Report of the
Drainage Outfall Committee

(Appointed by the Government of Bengal in the
Local Self-Government Department under
Resolution 1732 P. H., dated the 29th July 1931)

Report of the Drainage Outfall Committee appointed by the Government of Bengal in the Local Self-Government Department under Resolution No. 1732 P.H., dated the 29th July 1931.

The following diagram represents the bed and water surface of this channel:—

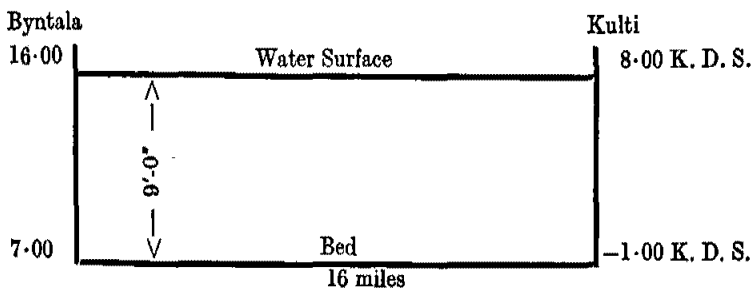
Point A is 20 miles from Kulti or 4 miles further west.

If the same slope is continued upwards along the channel the water surface levels would be:—

At point A 18.00 K. D. S.

At Palmer's Bridge 18.5 K. D. S.

3. I cannot find anywhere in Dr. Dey's original report or in his note of 22nd December 1931, any reference to the water level in the storm water channel at which the storm water in the sewers has a free outfall but it certainly would appear that a water surface level of 18.00 K. D. S. is too high to allow a free outfall of storm water from the sewers, at point A.

4. On page 8 of Mr. Ball Hill's report he states:—"It may be seen from Messrs. Hughes and Kimber's joint report April 1896 that.....the top water level at the outfall at Palmer's Bridge to allow the sewers a free flow should not rise above 12.50 K. D. S." On page 9 of the same report Mr. Ball Hill states:—"In order to admit of the storm water at Palmer's Bridge not rising above 12.50 it will not be safe to allow the top water level at Byntala to be above 11.50 K. D. S." If we accept 11.5 K. D. S. as the maximum water level at Byntala which will allow of free outfall of the storm water sewers and allow for a channel with a slope of 0.5 ft. per mile from there to Kulti (16 miles) the water surface level at Kulti would be 3.5 K. D. S.

5. This channel has to cross the Bidyadhari. Though the latter river has deteriorated it is still an outlet for drainage in the monsoon and could not be allowed to be blocked by the storm water channel. It would therefore be necessary to syphon the storm water channel under the Bidyadhari. Even if such a large syphon as 6 pipes of 8 ft. diameter is allowed for, the loss of head through the syphon would be 1.4 ft. We may, however, accept that the loss of head through the syphon could be reduced to 1.0 ft. The effect of the syphon crossing would therefore be to reduce the water surface level in the storm water channel at Kulti to 2.5 K. D. S.

6. If we allow for a very large sluice at Kulti say 12 openings of 8' x 6' or 576 sq. ft. of waterway the head necessary to discharge 2,500 cusecs through the sluice would be 0.5 ft.

7. A storm water channel carrying 2,500 cusecs starting with a water surface level of 11.5 at Byntala would therefore only have a free discharge at Kulti as long as water level in the Kulti was not higher than 2.00 K. D. S. In Table No. 8 accompanying Dr. Dey's letter No. S.—1872 of 22nd December 1931, the average low water level at Kulti from June to October is given as follows:—

1930	...	4' 6" K. D. S.
1931	...	4' 4" K. D. S.

It will therefore be seen that throughout the rains when the storm water channel would be required to function the lowest water level in the river would on an average be 2.5 ft. higher than the level of free discharge in the channel so that even at average low water level the water at the tail of the channel would be headed up 2.0 ft. The channel therefore never could empty itself by gravity.

The following diagram represents the proposed channel:—

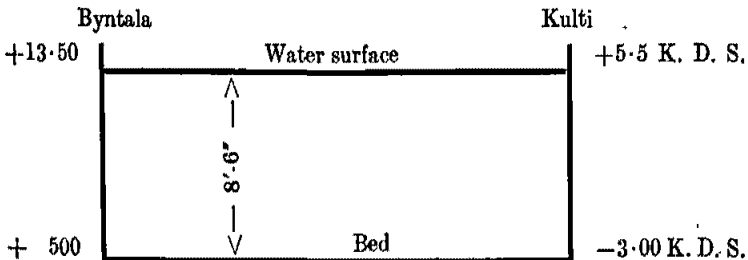
Subsequently in Annexure II to his note of 22nd December 1931 Dr. Dey showed the Dry Weather Flow channel with a water surface level of 15.00 K. D. S. at Byntala bed levels remaining as originally proposed. As Dr. Dey himself remarks the design is not good for

uniform velocity. The water surface is not parallel to the bed of the channel. The Committee have already pointed out to Dr. Dey that his assumption of a uniform water slope in the channel when water is headed up at the outfall is incorrect. If the channel is to carry the solid matters of the sewage a uniform slope without reduction of velocity at the outfall is essential.

11. Starting with a water surface level of 13.5 at Byntala and allowing a slope of 0.5 feet per mile in the 16 miles to Kulti the water surface level at Kulti would be 5.50 K. D. S. but we will have to allow 1 ft. loss of head in the channel at the Bidyadhari syphon as in the storm water channel which reduces the water surface level at Kulti to 4.50 K. D. S.

12. Allowing 3 sluices 8' x 6' or 144 sq. feet area of sluice a head of 0.5 feet is necessary to discharge 600 cusecs through the sluices. There will therefore be a free discharge without heading up in the channel only as long as tide level at Kulti is at 4.00 K. D. S. or below it. From Table No. 8 accompanying Dr. Dey's letter of 22nd December 1931 it will be seen that the average low tide level at Kulti throughout the year in 1930 was 3.7 (say 3.5 feet) K. D. S. The channel would therefore only have a full free discharge by gravity while the tide rose from 3.5 to 4.0 and discharge without heading up in the channel would cease when the tide rose to 4.5 K. D. S. From an examination of tidal curves at Kulti I find that the tide rises from low water at about an average of 1 ft. per half-hour. In half an hour after low tide it would therefore be necessary to pump the whole of the sewage discharge. A similar period of free discharge would be available on the falling tide so the total period of free discharge would be one hour per tide. For the balance or for about 22 hours out of the 24 complete pumping of 600 cusecs would be necessary. The period of free discharge is so short that it may almost be neglected, in other words the discharge of the Dry Weather Flow channel would practically have to be pumped continuously up to a maximum lift of about 11 feet at high tide. An outfall to Kulti therefore would not avoid having to pump the whole of the Dry Weather Flow.
